# Product Bulletin

## Commercial Availability & G-70-52-AM Clarification

11.25.08

The purpose of this bulletin is to clarify G-70-52-AM and Commercial Availability to explain the correct EVR hanging hardware requirements and hose configuration when replacing a non-EVR hose with an EVR-approved curb hose. CARB's Commercial Availability Advisory 374 (see attached) becomes effective on November 1, 2008, requiring GDF owner / operators to begin replacing non-EVR hanging hardware with EVR-approved hanging hardware.

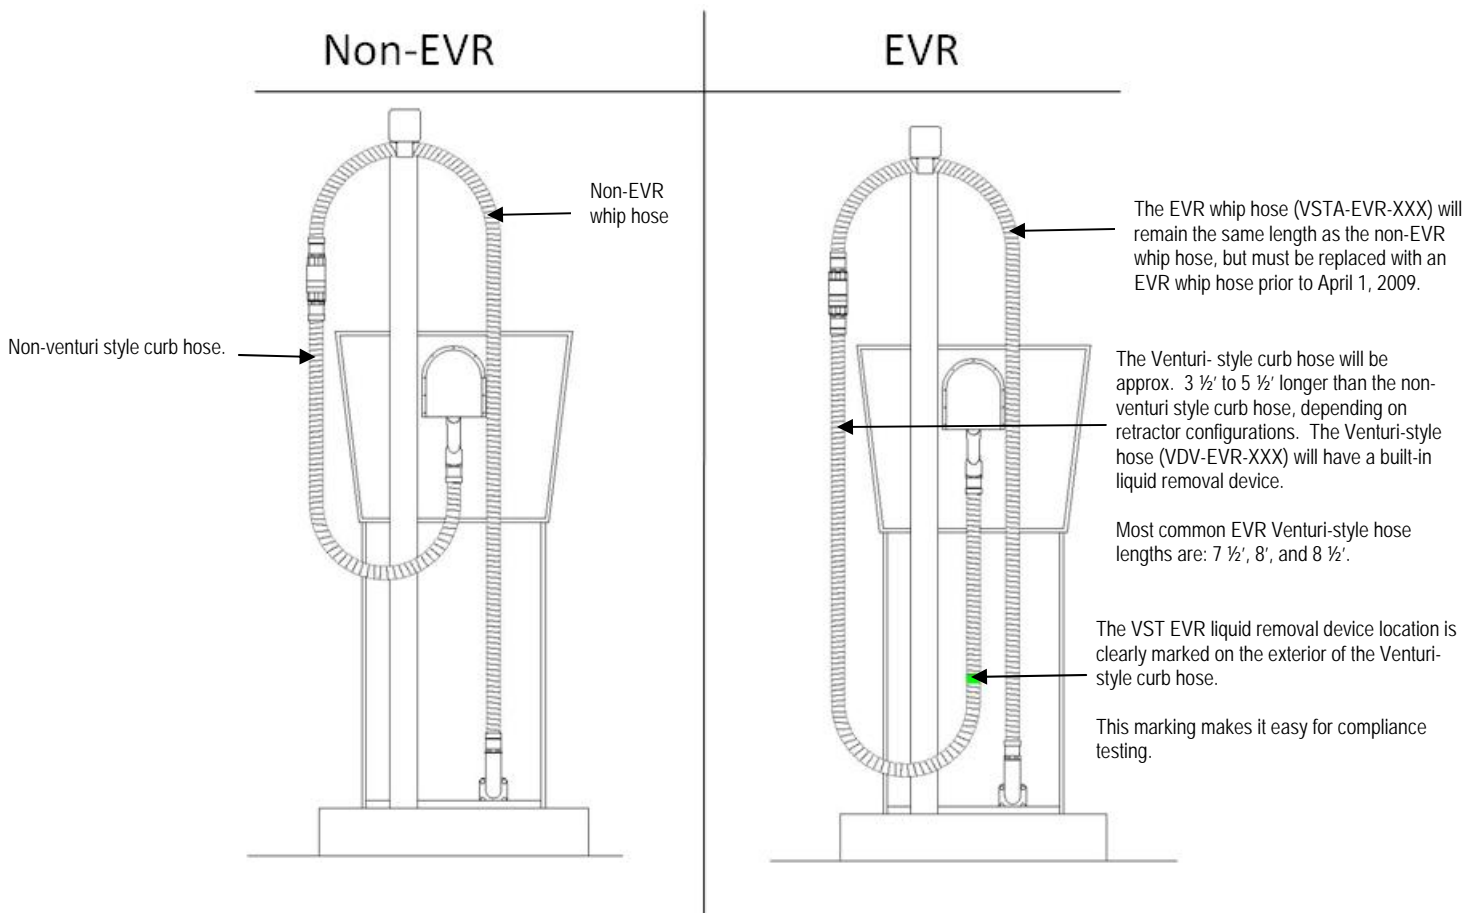
1. EVR-approved curb hoses must be a Venturi style, meaning they contain built-in liquid-removal devices.
  - VST is the only provider of Balance, EVR-approved, Venturi-style curb hoses for VST EVR systems.
2. Venturi hoses will be 3 ½' to 5 ½' longer than the existing non-EVR curb hose to allow the Venturi hose to function properly.
3. The whip hose will remain the same length.
4. If you intend to install a VST EVR balance system, below is an example of a proper hose geometry conversion.
